ADDENDUM #2
to
ENVIRONMENTAL IMPACT ASSESSMENT

BAHIA PRINCIPE HOTEL
RESORT DEVELOPMENT

PEAR TREE BOTTOM
ST. ANN, JAMAICA

JUNE 2005

Figure showing topographic contours – substitute for Fig. 3.1.2 in EIA report.

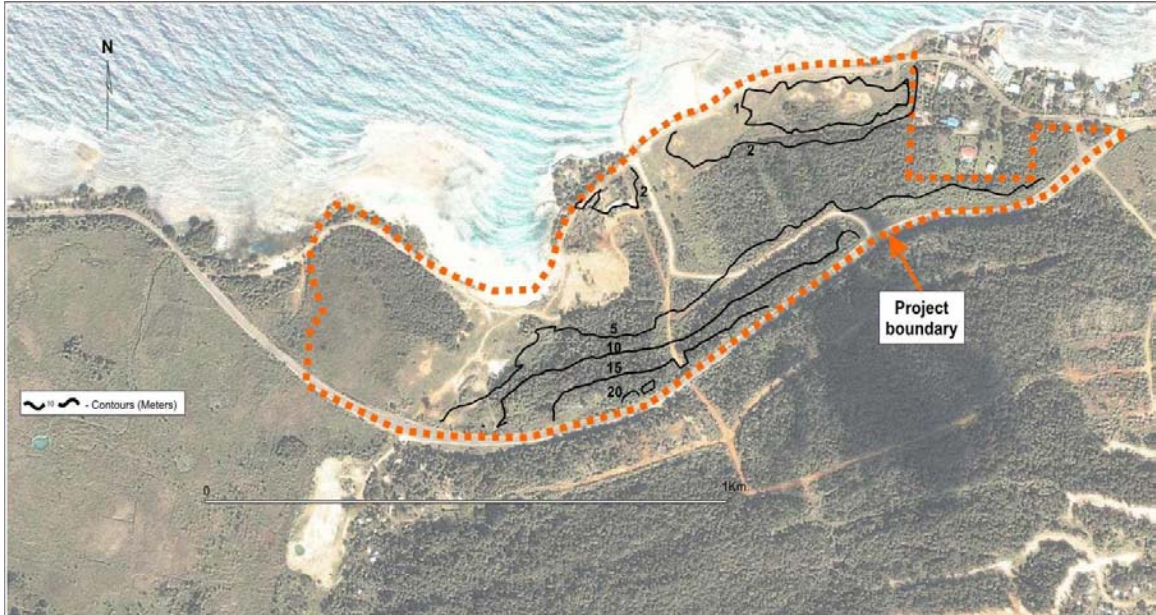
- The figures presented in the EIA, especially those with the aerial photographs as the backdrop are of poor quality and need to be addressed. This is especially the case where the colours (light yellow, pale yellow) used to highlight the various components of the hotel development are camouflaged by the vegetation (green colour).

As worded, the comment incorrectly suggests that all the figures presented were of poor quality. Figures 3.1.2 and 4.1 have been redone and are provided in the Appendix below

Figure showing master plan of resort – part substitute for Fig. 4.1 in EIA report.

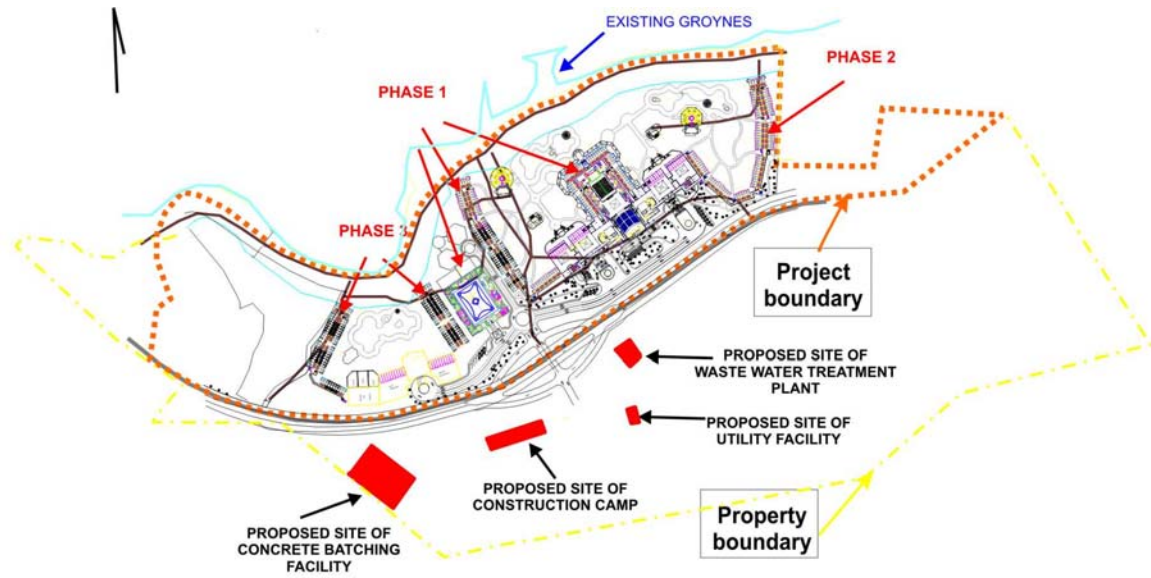
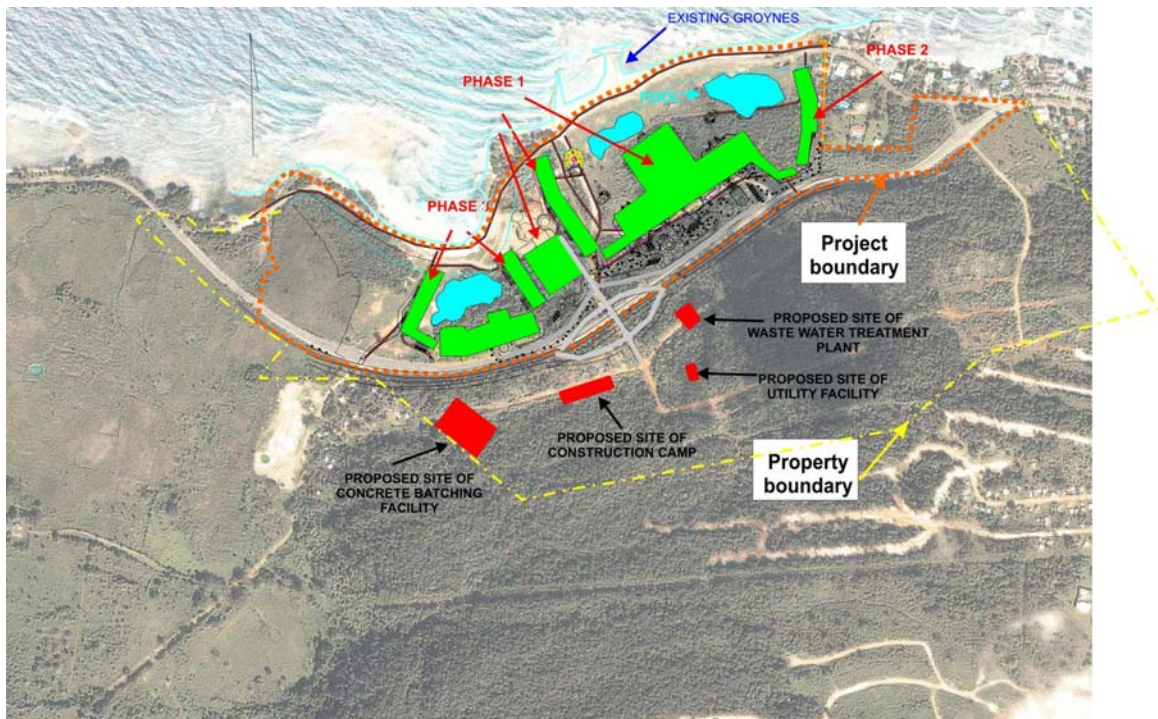
- **Page 79, Section 4.2.1 – Site preparation activities.** The location of the plant nursery is not evident on Figure 4.1 (Page 78).

The exact location has not been determined. Initially it is intended to use the facilities of a landscape operation near to Green Grotto
